# SOLD ON KĀPITI

## APPLICATION FOR PERMIT

MR.N.GRIDLEY, 73 LANGDALE AVENUE, TOWER LAKES, PARAPARAUMU.

SITE INVESTIGATION.
73 LANGDALE AVENUE,
LOT 17, TIKOTU SETTLEMENT, TOWER LAKES.

## GARAGE FOLKDATION RAN

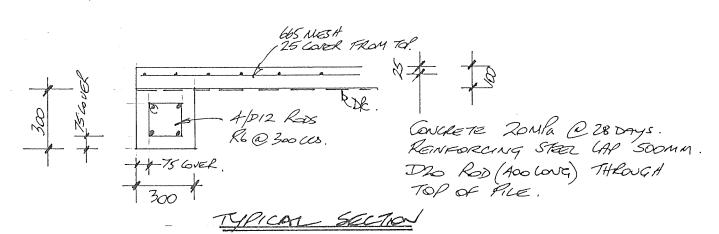
Please find attached the site report, design certificate and calculations for the garage foundations for the dwelling to be constructed at the above address.

#### SCALA PENETROMETER TESTS

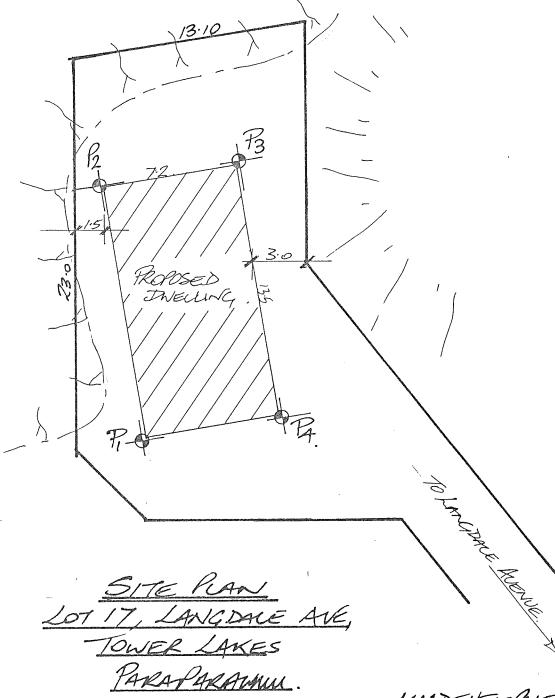
The ground conditions are consistent with the sandhill country in this region where the sand types are of variable consistency to a depth of approximately 1500mm below ground level where reasonably solid ground can be found. The results on this site are influenced by the bank bordering the lake on the S/W side of the section which is quite soft to depths of 2500mm below the level of the platform.

NZS 3604: Light Timber Frame Buildings defines solid bearing as 12 blows per 300mm, in this instance the depths at which these figures were achieved were:

The site does not meet the minimum founding requirements of NZS 3604: "Code of Practice for Light Timber Frame Building."

As the surface ground conditions do not meet the minimum founding requirements of NZS 3604 it will be necessary to carryout remedial measures to bring the site up to the required standards. In view of the variable nature of the ground the whole site has to be treated as suspect, the options available to provide suitable support for the house are:

- a) Remove all unsuitable material down to solid ground and replace with clean compacted fill. The depth of the excavation together with the elevated site make this option impractical.
- b) Drive ground treated tanapoles through the unsuitable material and into the solid ground below. The poles should be driven a minimum depth of 1900mm below ground level whilst also achieving a minimum set equivalent to a settlement load of 10 tonnes. For the majority of driving equipment available in the area this equates roughly to 10 blows of the hammer per 250mm penetration of the tanapole.

73 Langdale Plue Existma drainage Plan 1.30eep 1.8 R.O.W DT Peter Comptell 25.3.91

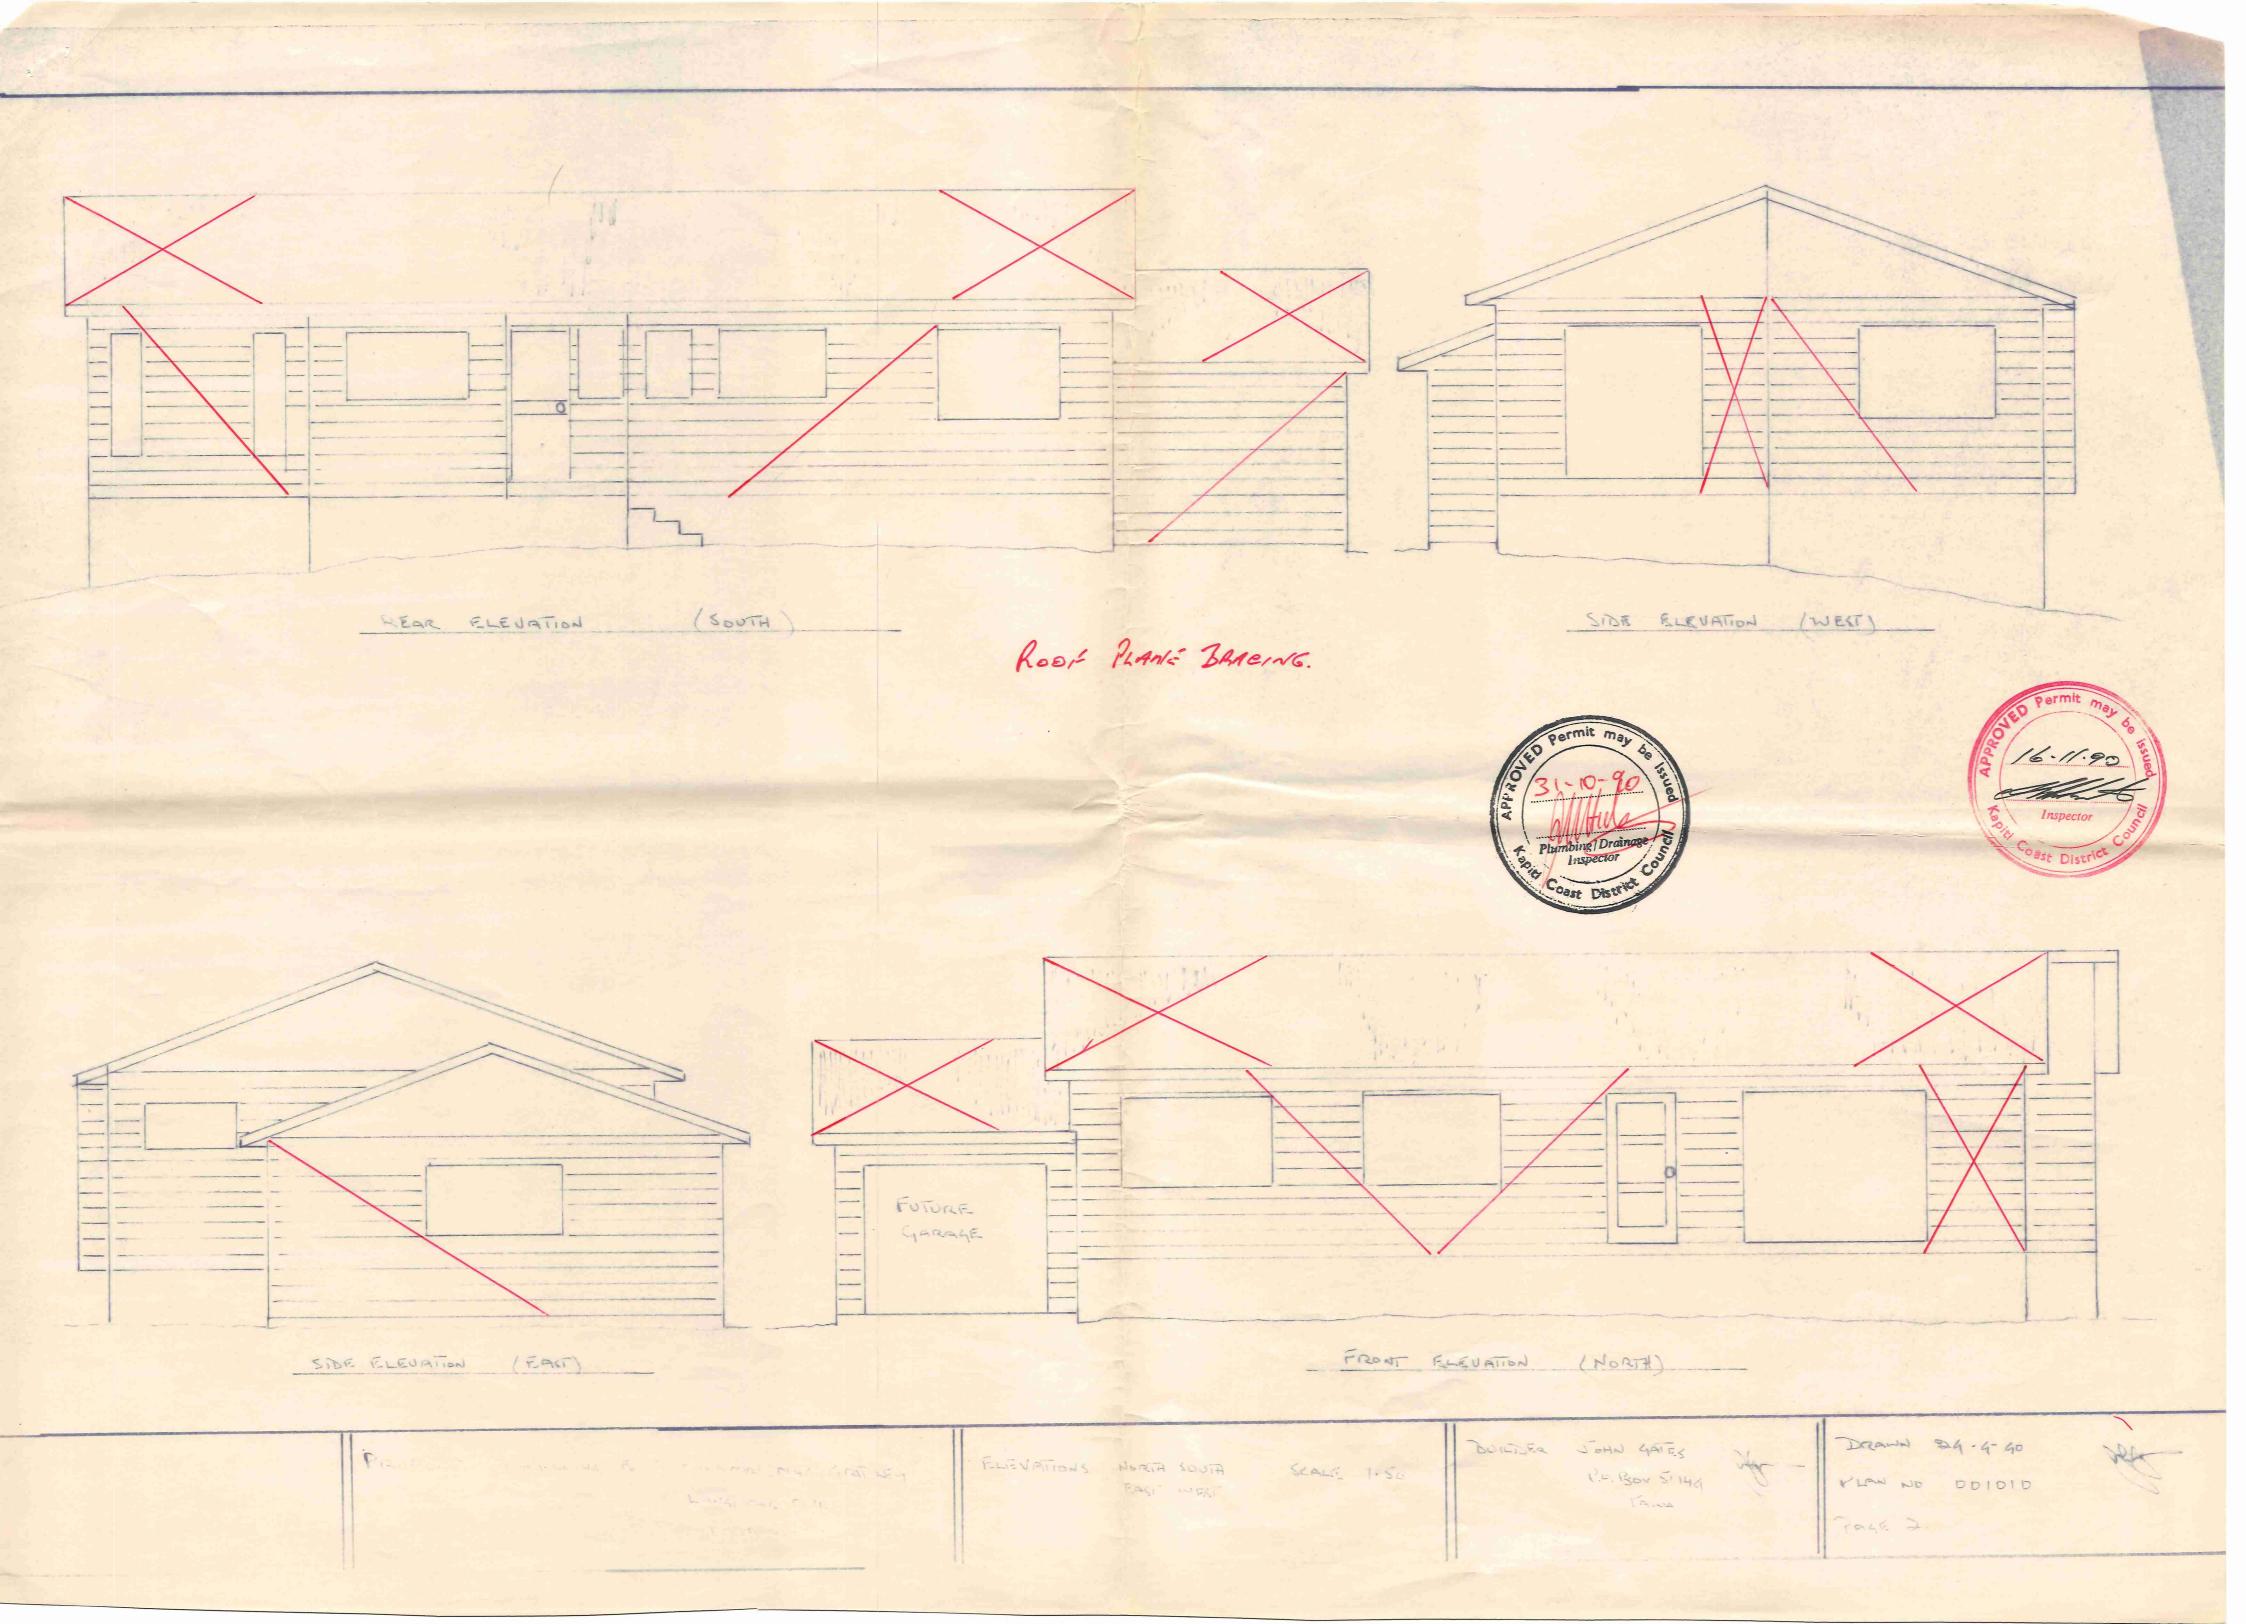
It has come to my attention that the stormwater pipes from 73 Langdale Avenue are discharging to 85 Langdale Avenue which is contrary to Councils drainage requirements and the Land Drainage Act.

Irrespective of the outcome of that appeal, the stormwater discharge from your property must be changed either to discharge to soak pits within your property or to the curb and channel at Langdale Avenue.
